## **Request for authorization to develop an amendment to global technical regulation No. 6 (Safety Glazing)**

### **Submitted by the representative from Republic of Korea**

Figure 4: Determination of Zone I

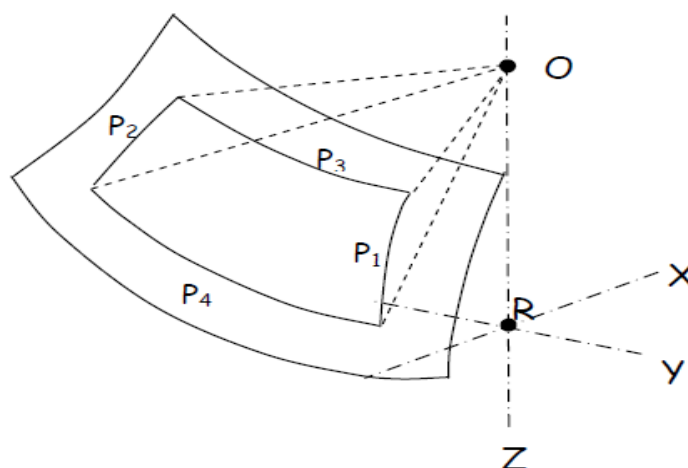
7.1.3.3.2. Zone I is the zone determined by the intersection of the windscreen with the four planes defined below:

**In addition, opaque obscuration can be exempted in Zone I. It is the limited areas where it is intended that a sensing device, e.g. a rain-drop detector, rear view mirror or autonomous vehicle sensors, will be bonded to the inner side of the windscreen. The opaque obscuration where such devices may be applied is defined in paragraph 7.1.3.2.4.(Figure 2(a) or Figure 2(b)) of this annex.**
